NOTICE OF PUBLIC HEARING
Minor Variance

APPLICATION NO.:	A-24:177	SUBJECT PROPERTY:	371 Skinner Road, Flamborough
ZONE:	R4-6 Urban Residential (Semi-detached and Link)	ZONING BY-LAW:	Zoning By-law Flamborough 90-145-Z

RE: 371 SKINNER RD FLAMBOROUGH
Building Permit Application Number 24T-1647
Building Permit Application Review Letter 2

TITLE
**371 SKINNER ROAD,
HAMILTON , ON
SITE PLAN**

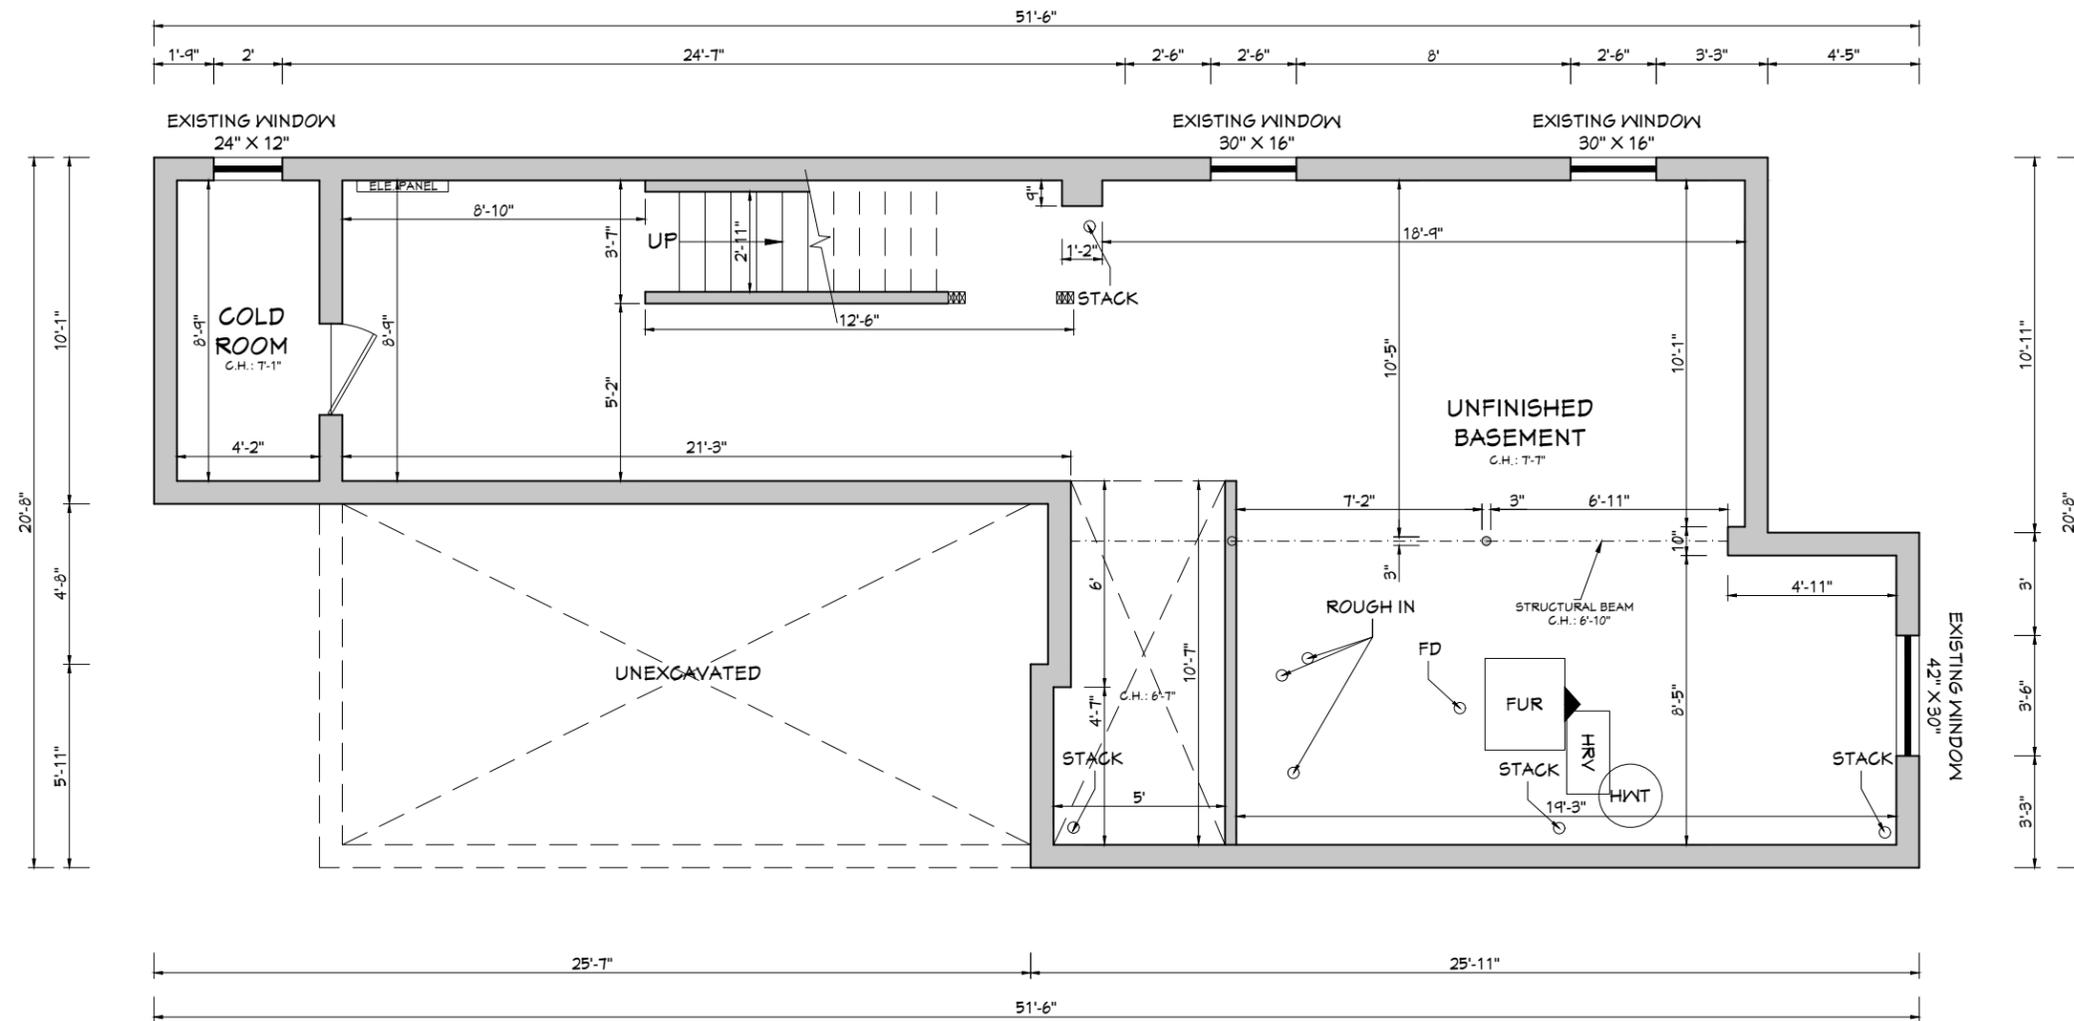
Item	Zoning	Reference
Z1.	<p>Further to review item Z1 of review letter 1;</p> <p>The proposed secondary dwelling unit requires 1 parking space (2.6m x 5.8m) in addition to the existing parking space for the semi-detached dwelling unit.</p> <p>Note that tandem parking is not permitted for the parking spaces for each of the dwelling units.</p> <p>Provide a revised design to detail the required parking spaces in compliance to the zoning bylaw or gain approval through the Committee of Adjustment for a minor variance (cofa@hamilton.ca).</p>	Bylaw 90-145-Z Section 5.21.1. & 5.43(a)

TITLE **371 SKINNER ROAD, HAMILTON, ON PROPOSED BASEMENT**

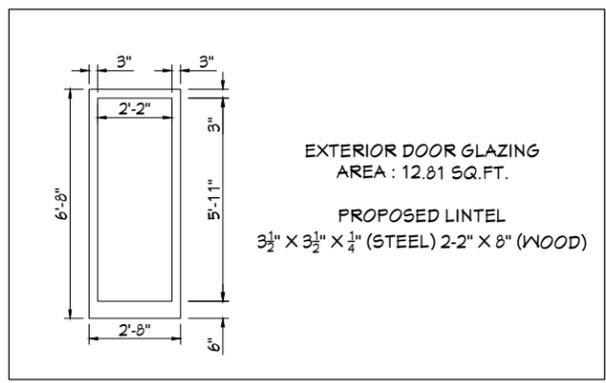
Item	Ontario Building Code	Reference
	Unless otherwise noted all Ontario Building Code (OBC) references are Division B; [A] - Division A; [C] - Division C.	
C1.	Based on the revised design submitted for review cycle 2, clarify the intended purpose of adjoining the	OBC Div. Part 11 C136

<p>basement dwelling unit with the main floor of the single family dwelling (semi-detached), provide path of compliance in the Ontario Building Code.</p> <p>If the adjoining of dwelling units is for the purpose of egress in relation to compliance alternative C136(c), clearly note this on the drawings.</p>	
C2.	<p>Pending review item C2, the basement dwelling unit appears to have one means of egress. The windows above the unenclosed exit stairway on the main and second floor are required to be protected.</p> <p>Provide a revised design to detail compliance.</p>	OBC Div. B Part 9.9.4.4.
C3.	<p>Based on the revised design submitted for review cycle 2; a clear height of 2.1m under the deck is required to access the entrance of the proposed secondary dwelling unit located within the basement.</p> <p>Provide a revised design to detail the passage to the entrance with sufficient ceiling height.</p>	OBC Div. B Part 9.5.3.1.
